Well Name: BIG EDDY UNIT DI 30
WEST 15-17

Operator: XTO PERMIAN OPERATING
LLC

Sundry ID: 2822475

BIG EDDY UNIT DI 30 West 15-17 4H
APD ID# 10400097387
SUNDRY LANGUAGE

[Figure E] 4 String – Uncemented Annulus between 2nd Intermediate and Production Casing Strings. (Reference R-111-Q: Exhibit B)

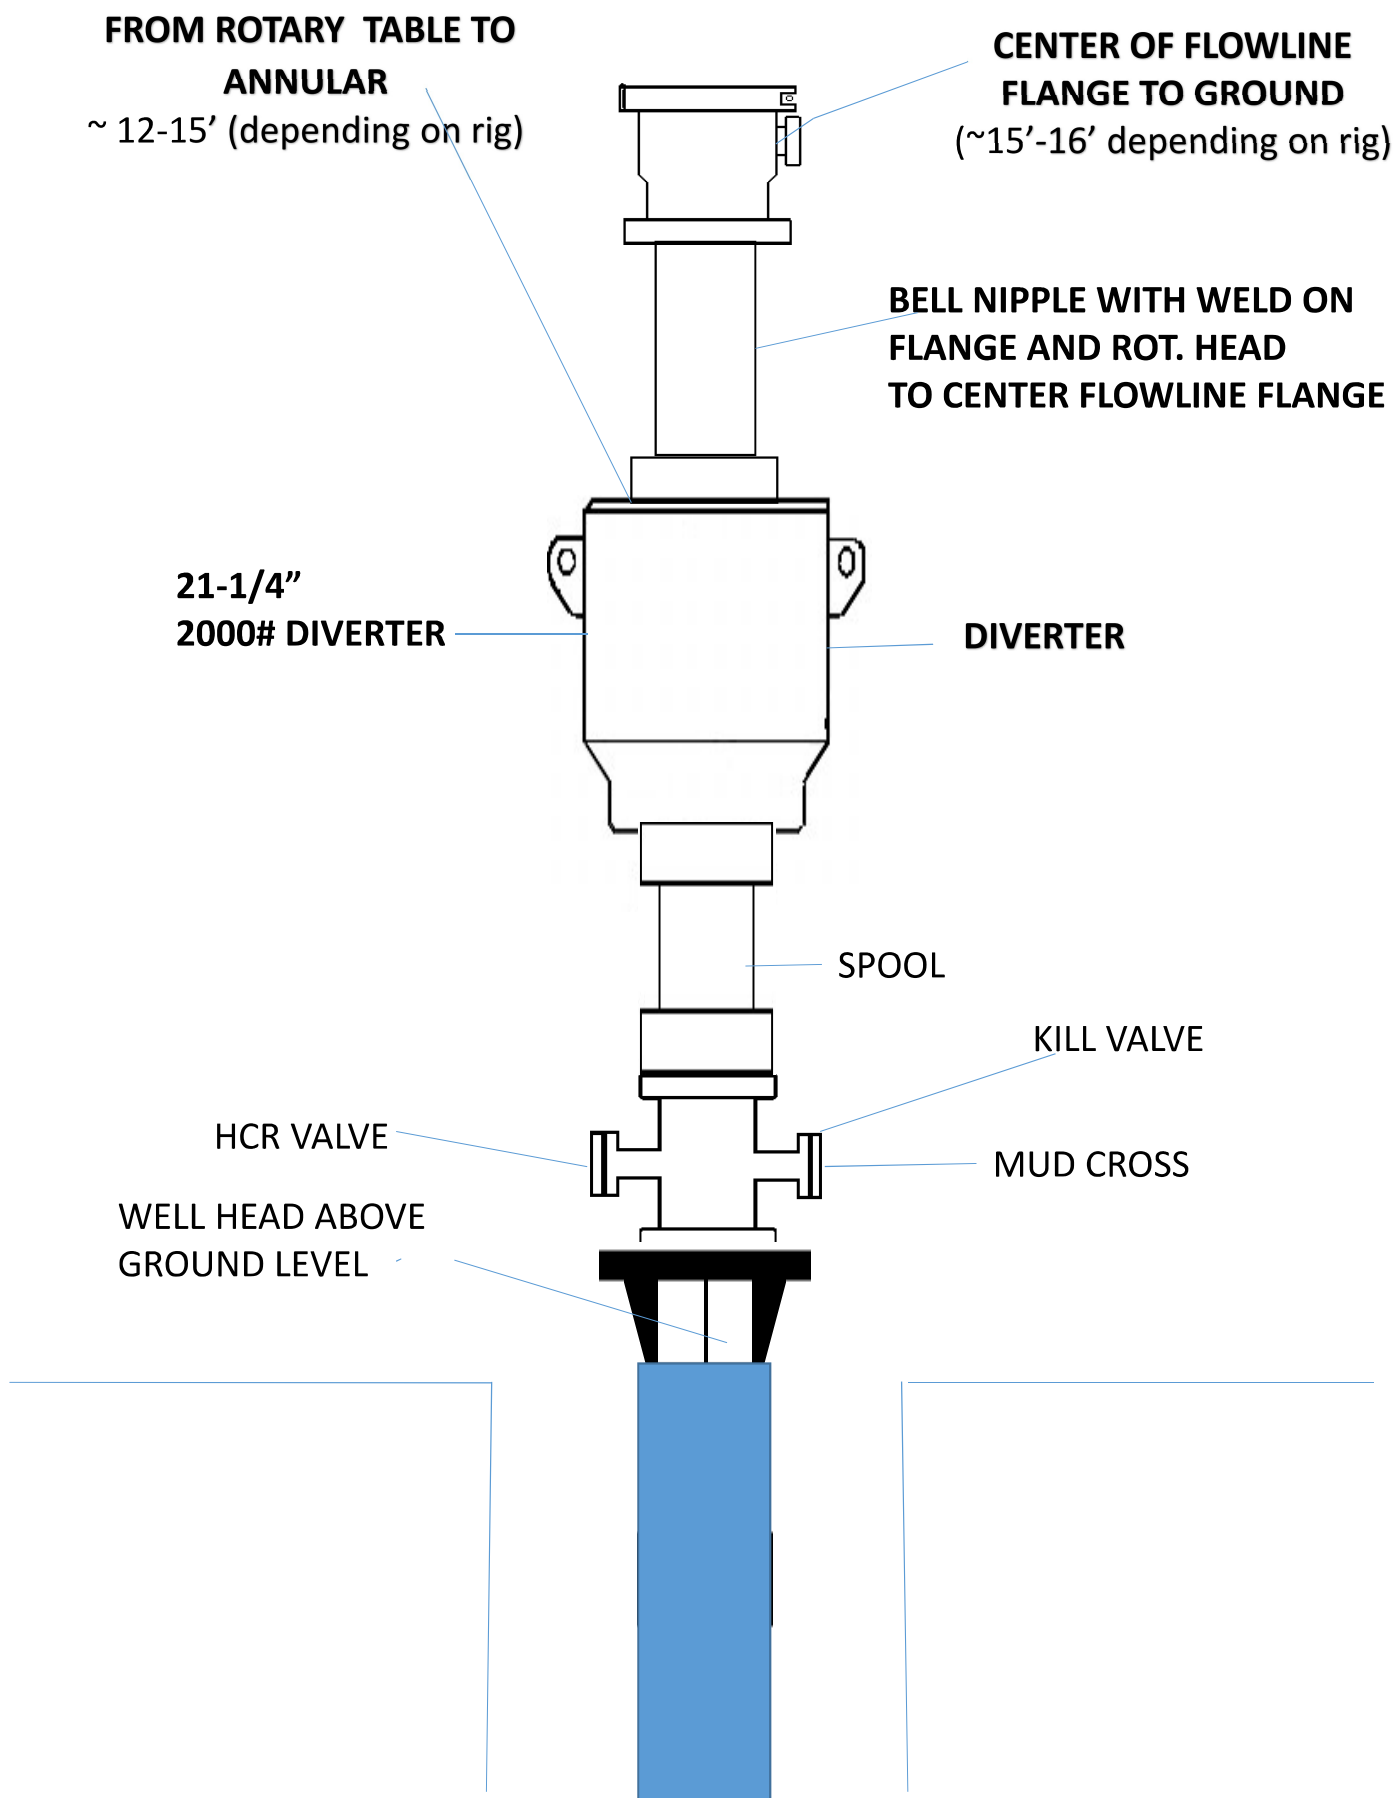
- Casing design to be changed from a proposed 4-string engineered weak point design to a 4-string design with an uncemented annulus between 2nd intermediate and production casing strings
- Associated changes required in the cement program & the mud circulation system as per the newly proposed casing design mentioned above

Open 2nd intermediate x production annulus to monitor during completion. In the event of production casing failure, pressure will either release at surface or into the formation below 2nd intermediate shoe in the Delaware Mountain group / Brushy Canyon relief zone (R111Q Figure E)

- Alignment with KPLA requirements per schematic below, with open 2nd Int x production casing design and utilizing new casing that meets API standards.

- Production casing will consist of a primary cement job with TOC at the top of the Brushy Canyon formation within the Delaware Mountain Group with 0% excess and well below the minimum of 500' from Intermediate 2 casing shoe.

TEST REPORT

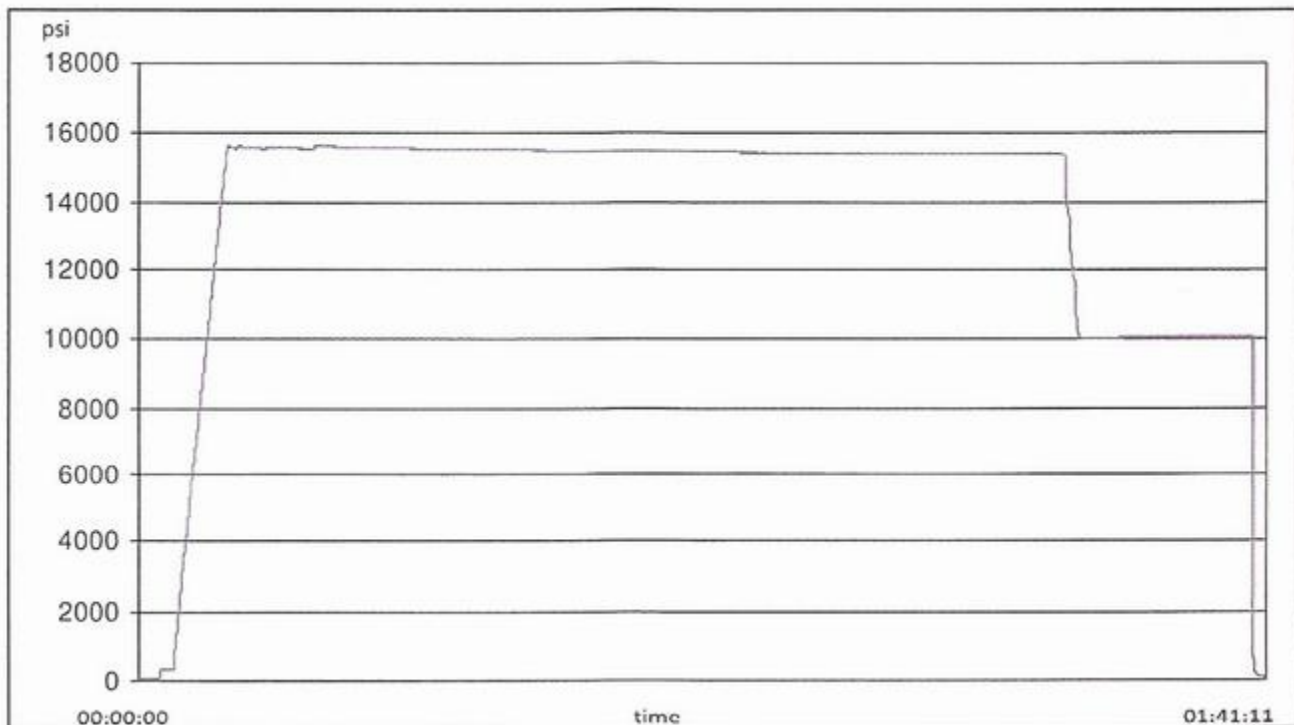
A variance is requested to allow use of a flex hose as the choke line from the BOP to the Choke Manifold. If this hose is used, a copy of the manufacturer's certification and pressure test chart will be kept on the rig. Attached is an example of a certification and pressure test chart. The manufacturer does not require anchors.

1. Variance approved to use flex line from BOP to choke manifold. Manufacturer's specification to be readily available. No external damage to flex line. Flex line to be installed as straight as possible (no hard bends).
